Subject: 01-0003-RR	Responses to the NRC questions related to Relief Requests 01-0002-RR and
Creation Date:	10/14/01 1:43PM
From:	"Cecilia, Loretta V." <loretta.cecilia@pgnmail.com></loretta.cecilia@pgnmail.com>

Attached are the responses to the NRC questions related to Relief Requests 01-0002-RR and 01-0003-RR posed during our teleconference on October 11, 2001. During that discussion the NRC stated that the questions represented points of clarification as distinct from technical issues with the intended RPV head nozzle repair process. Accordingly, FPC representatives stated that repair welding would continue as planned. There was no indication from the NRC staff that proceeding with the repair held any regulatory risk.

Relief Request 01-0003-RR

Figure 1 Typical IDTB Weld Configuration with Weld Solidification Anomaly

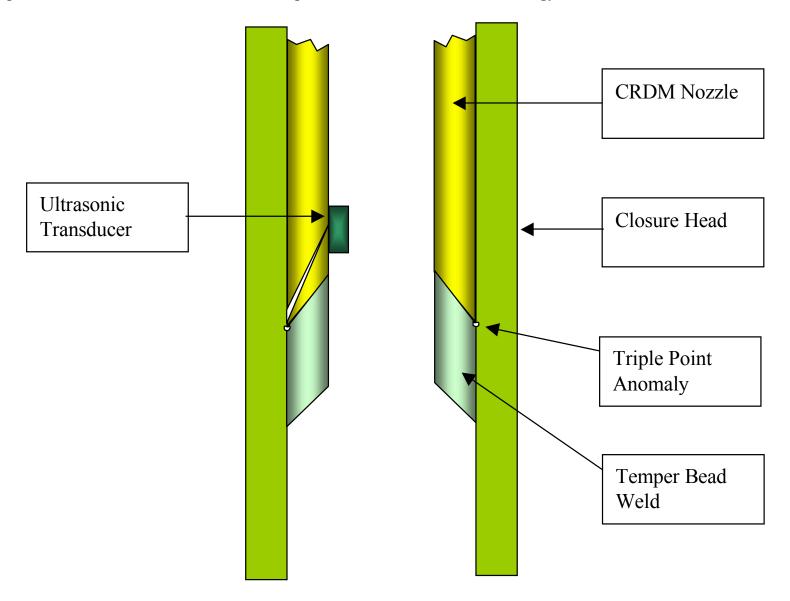
The effectiveness of the UT techniques to examine the ID temperbead (IDTB) repair weld have been qualified by demonstration on a mockup of the IDTB involving the same materials used for repair. Notches were machined into the mockup at the triple point region of depths of 0.10 inch, 0.15 inch, and 0.25 inch in order to quantify the ability to characterize the depth of penetration into the nozzle. This is illustrated in Figure 1. The depth characterization is done using tip diffraction UT techniques that have the ability to measure the depth of a reflector relative to the nozzle bore. Each of the notches in the mockup could be measured using the 45-degree transducer. During the examination longitudinal wave angle beams of 45 degrees and 70 degrees are used (refer to Figure 2). These beams are directed along the nozzle axis looking up and down. The downward looking beams are effective at detecting the anomaly because of the impedance change at the triple point. The 45-degree transducer is effective at depth characterization by measuring the time interval to the tip of the reflector relative to the transducer contact surface. This provides the ability to determine if the anomaly is within the limits of the analyzed 0.10 inch flaw size. The 70-degree longitudinal wave provides additional qualitative data to support information obtained with the 45-degree transducer. Together, these transducers provide good characterization of the solidification anomaly. These techniques are routinely used for examination of austenitic welds in the nuclear industry for flaw detection and sizing.

Detection of the solidification anomaly has also been demonstrated on mockups fabricated during the welding qualification activities. The techniques detected the anomaly and were subsequently sectioned. The anomaly was generally less than 0.03 inch for the samples sectioned.

Figure 3

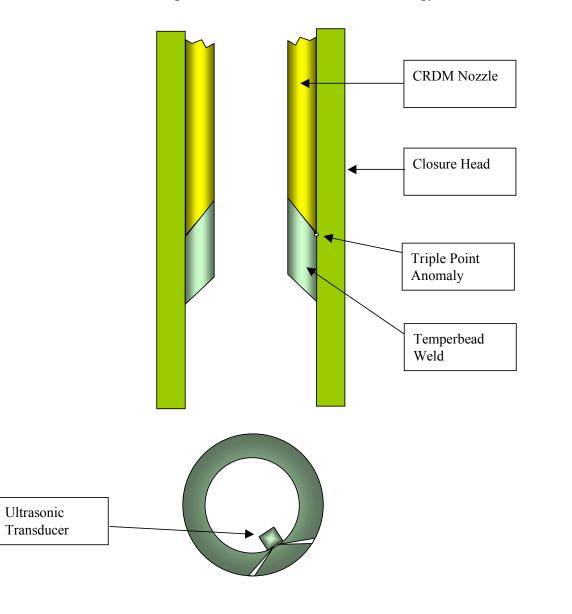
In addition to the 45 and 70-degree beam angles described above the weld is also examined in the circumferential direction using 45-degree longitudinal waves in both the clockwise and counterclockwise directions to look for transverse fabrication flaws (refer to Figure 3). A 0-degree transducer is also used to look radially outward to examine the weld and adjacent material for laminar type flaws and evidence of underbead cracking (refer to Figure 4).
